Re: Indian Point Unit 3
Docket No. 50-286
NL-05-010

**Subject: Reply to RAI regarding Indian Point Unit 3 Relaxation Requests
for Inspection of Reactor Pressure Vessel Head per NRC First Revised
Order, EA-03-009 (TAC No. MB3195)**

**REPLY TO NRC REQUEST FOR ADDITIONAL INFORMATION
REGARDING RELAXATION REQUESTS FOR INSPECTION
OF IP3 REACTOR PRESSURE VESSEL HEAD**

**ENTERGY NUCLEAR OPERATIONS, INC.
INDIAN POINT NUCLEAR GENERATING UNIT NO. 3
DOCKET NO. 50-286**

FIGURE 1
IP3 - PENETRATION NOZZLES
NOS. 74 THROUGH 78 (TYP.)

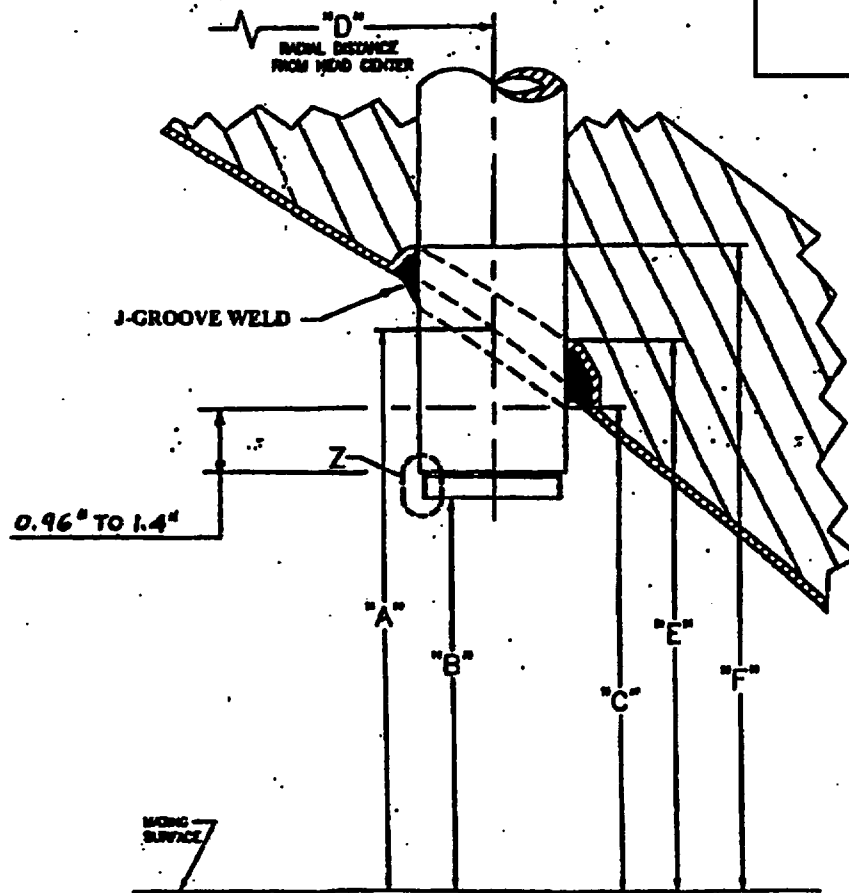
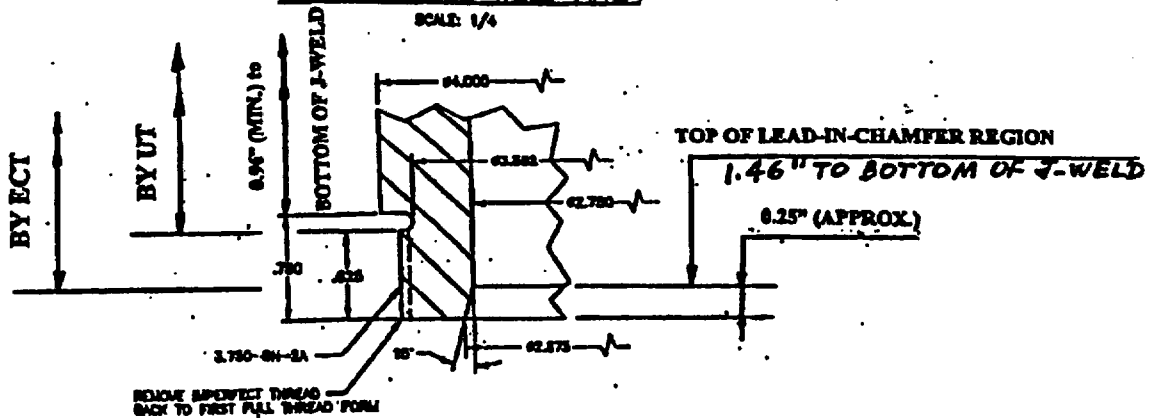
Provide a summary of the crack growth calculation describing the methodology used, including the input assumptions and results. Discuss whether the crack growth rates assessed were based on the equations in MRP-55 and whether the crack growth evaluation was based on the as-built weld geometry.

The First Revised Order allows either ultrasonic testing (UT) examination or a surface examination (i.e. liquid penetrant or eddy current) to be performed. Discuss why a surface examination is not being considered for the threaded area of the five penetration nozzles identified. A surface examination would provide meaningful results on the threaded regions. Discuss any hardships that would be imposed by performing the surface examination (dose, safety risks etc.).

A crack growth evaluation was performed using the methods of MRP-55 for crack growth caused by primary water stress corrosion cracking at a head temperature of 592 degrees F. The nozzle is an open-ended tube so that the operating pressure and temperature are essentially the same at both the inside and outside surface of the tube. For purposes of this analysis, a conservatively high hoop stress of 30 ksi was assumed, as compared to the calculated stresses of less than 20 ksi as noted above (Reference 5, First Revised Order EA-03-009, page 10). An initial hypothetical flaw is assumed to exist with a worst-case orientation (axial) and flaw growth occurs in a single direction toward the J-groove weld. Because the location of the hypothetical flaw is in the threaded region, at least 0.96 inches from the J-groove weld, the weld residual stresses are also negligible. The evaluation confirmed that the hypothetical flaw would not grow to the J-groove weld over at least 4 years of operation. The weld geometry dimensions are taken from the IP3 plant specific drawing (IP3V-0439-1680) entitled: "Indian Point Unit 3, RVH Penetration Inspection, Interface Dimensions". Refer to the attached Figure 1 for the location of these dimensions on the penetration nozzles.

The inspection methods and results performed during Refueling Outage 3R12 in April 2003 were submitted in Entergy's letter to NRC, NL-03-098, dated June 12, 2003. The non-visual NDE portion of the examination for the referenced five penetration nozzles was performed using a single probe assembly that contained a pair of transducers for the UT examination and an eddy current coil for the ECT surface examination. The axial coverage with this probe assembly extended down to approximately 0.75 inches from the bottom of the nozzle (for the UT exam) and down to approximately 0.25 inches from the bottom of the nozzle (for the ECT surface exam). Meaningful UT data below approximately 0.75 inches was limited by signal dispersion in the threaded region. Meaningful ECT data below approximately 0.25 inches was also limited

because the eddy current coil tends to lose contact with the examination surface as it reaches the lead-in chamfer region (see attached Figure 1). As discussed in the response to Question 3a above, the hardships in removing the guide funnels welded to the bottom of the nozzles precludes examination of the OD wetted surface areas of the nozzle tubes.
